DEPARTMENT OF ECOLOGY

M E M O R A N D U M

To: Jim Oberlander  
From: Bill Yake, Ambient & Effluent Monitoring  
Re: Flow Measurement at Crystal Mountain STP,  
Pierce County

Figure 1. Crystal Mt. STP - Configuration of Inflow and Outfall.

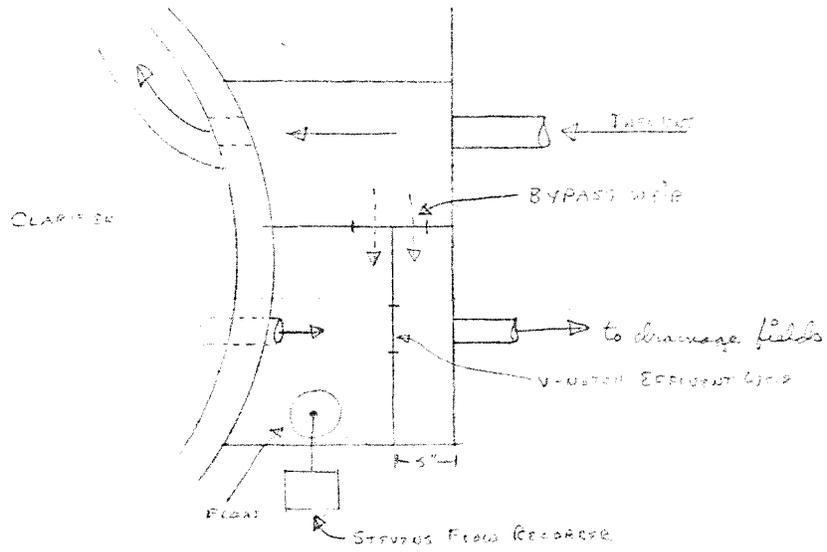
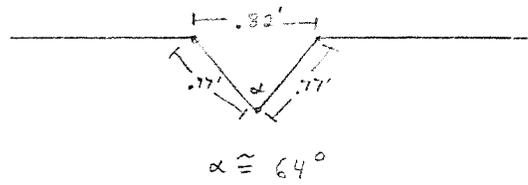
Inspection was made of the flow measuring and recording equipment at the Crystal Mountain STP on March 12, 1978. The configuration of the inflow and outfall structures of the plant is presented in Figure 1. The Stevens 61R recorder, which is activated by a float behind a V-notch weir, records instantaneous and totalized flow. The instantaneous flow is indicated by a needle which scribes a strip chart. The instantaneous flow dial is graduated from 0 to .175. The script chart graduation are not denoted. It is assumed that the 0 to .175 graduations are mgd units. The totalizer is provided with a digital readout. One unit represents 50 gallons. The outfall configuration is poorly designed for accurate flow measurement. The following deficiencies were noted:

- 1) The weir is not a standard 60° weir. The base angle is about 64°, thus real flows are underestimated.
- 2) The weir is not sharp crested and the nappe does not spring free from the weir in the lower section of the V-notch.
- 3) The flow through the weir is not allowed enough drop to prevent weir submergence when flows are high.
- 4) Dimensions of the outfall structure are cramped making accurate calibration almost impossible.

- 1) The flow recording device at the Crystal Mountain STP was severely out of calibration when inspected on 3/11/78. It was recording only approximately 17-20% of the 'actual' flow.
- 2) After the operator "corrected" the meter it continued to record only approximately 62-65% of 'actual' flow.
- 3) The 'actual' flows are probably underestimated as the weir's base angle was greater than 60° and head was measured at the weir, rather than upstream.
- 4) Maintenance and calibration of the flow measuring system by operating personnel is questionable.
- 5) Very little faith may be placed in the flow measurements recorded by the Crystal Mountain STP due to deficiencies in design, calibration and maintenance.
